TAX ID #
ON-SITE SEWAGE DISPOSAL SYSTEM
HOWARD COUNTY HEALTH DEPARTMENT
BUREAU OF ENVIRONMENTAL HEALTH

SUBDIVISION: Edgewood Farm LOT NUMBER: 4

ADDRESS: 14517 Edgewoods Way PROPERTY OWNER: Toll MD LP

WALLCHECK
LOT #04
EDGEWOOD FARM
LIBER 4174, FOLIO 0436
PLAT No. 19256, et seq
FOURTH ELECTION DISTRICT
HOWARD COUNTY, MARYLAND

TRENCH/DRAINFIELD DATA

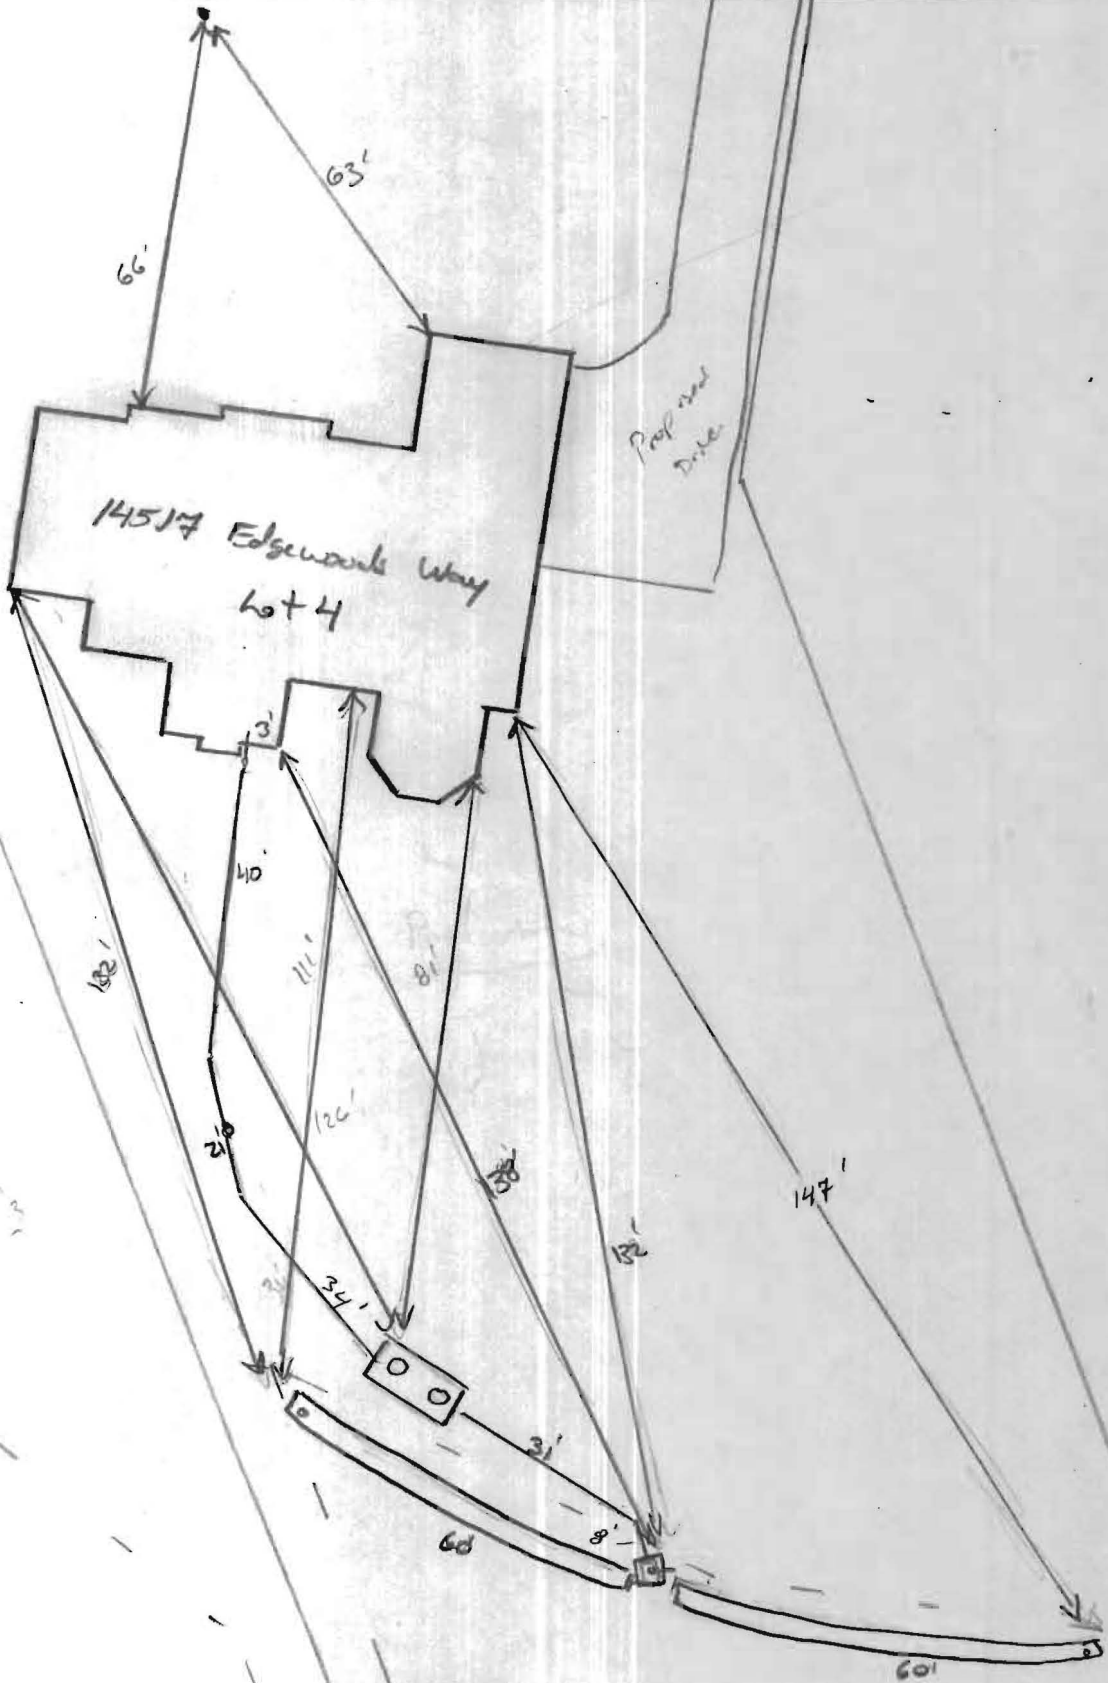
7/19/10 Contractor to
set tank close to
where shown on approval
BP but out of SRA.
Set D box on top

center of SRA, install 2x60' ^{frank} w/ speck shown rising with elevation (1cu)

INSTALLATION: 7/20/10 All parts of system complete. Need levels marked
and then on tank. OK to cover everything but Dist. box (pu)
7/21/10 D box leveled. Risers installed on tank. Stone clean
1/2 from redford, 1/2 from sewage, OK to cover all work (pu)

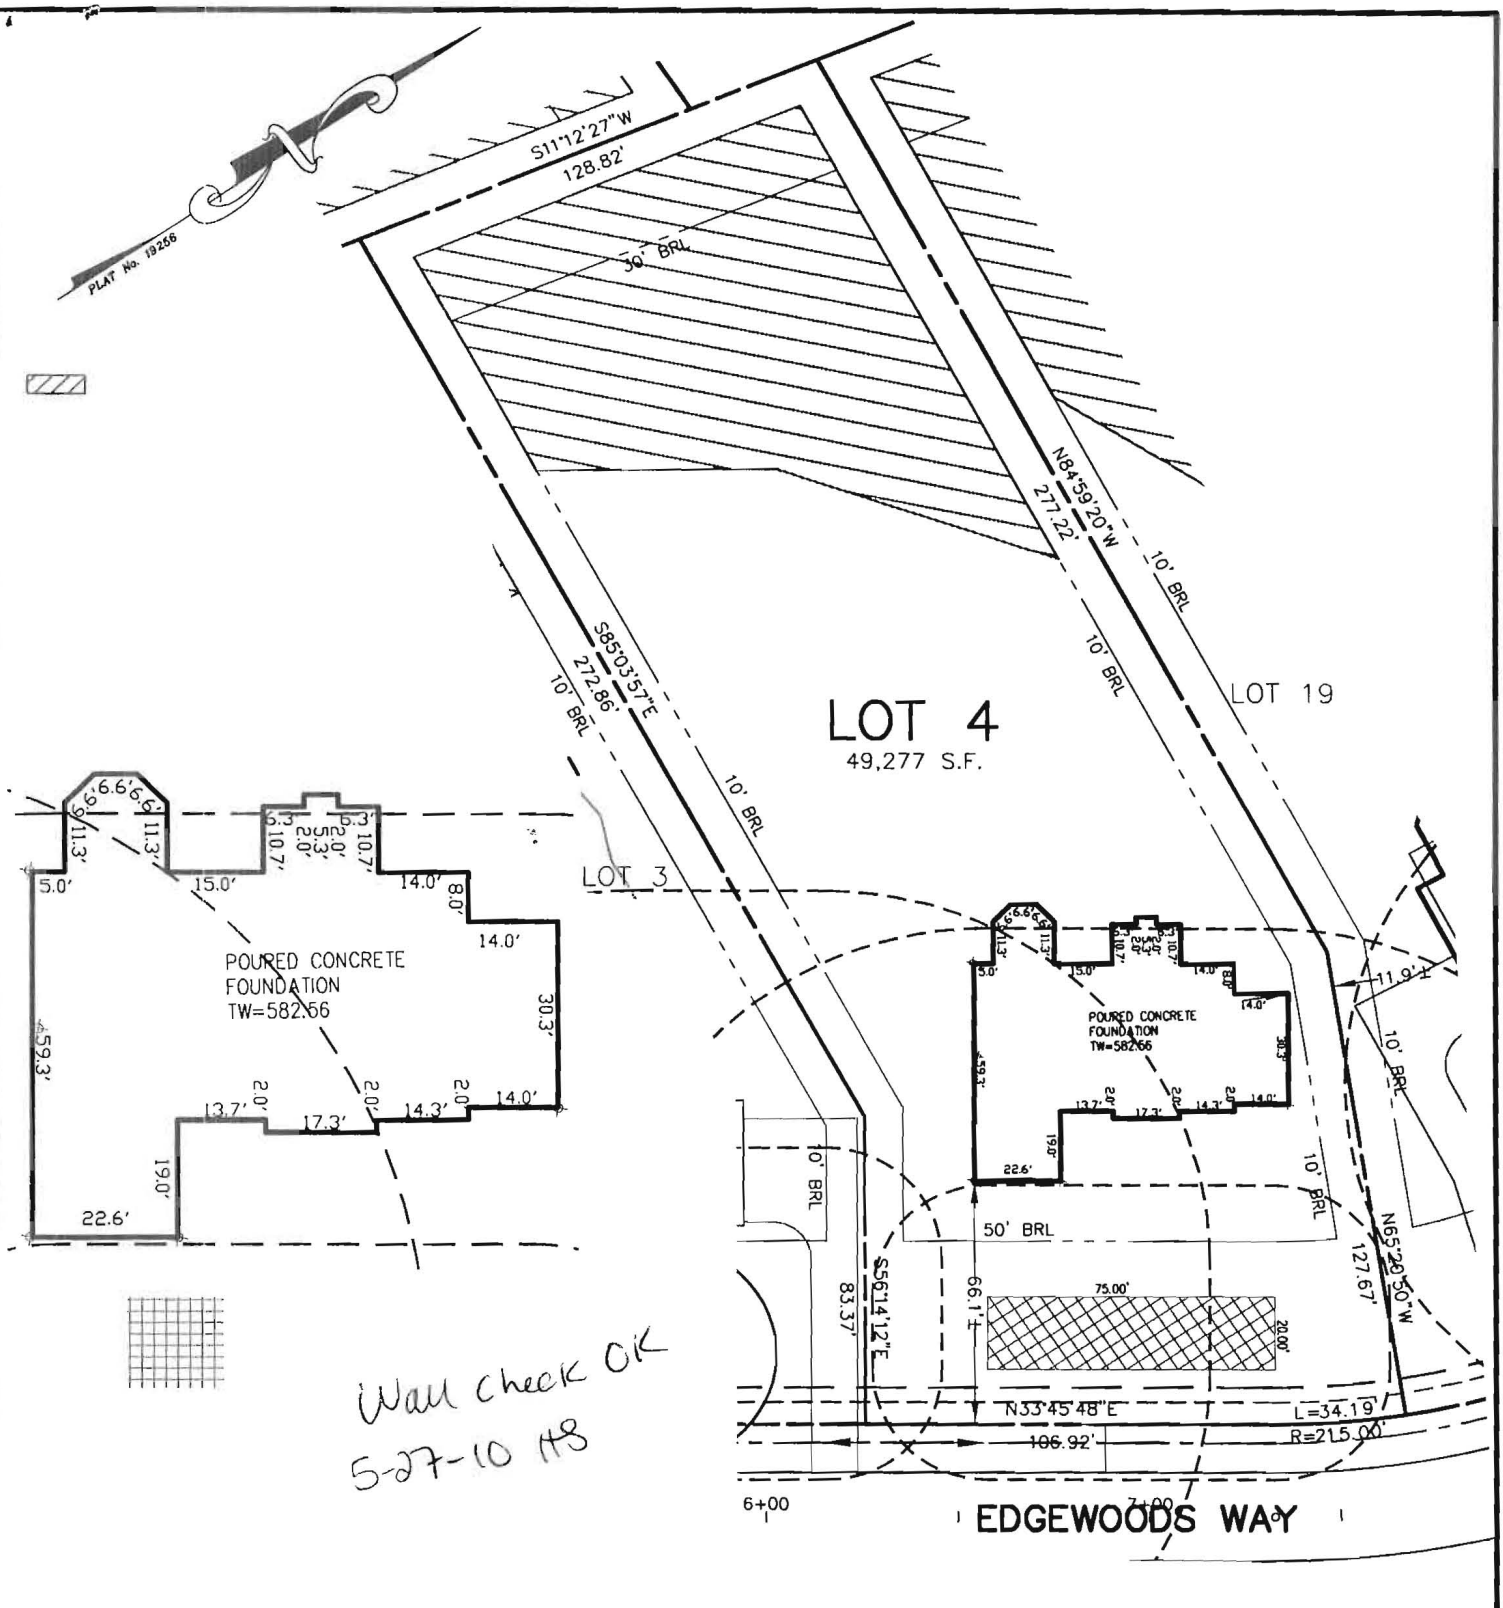
Wall check OK
5-27-10 MS
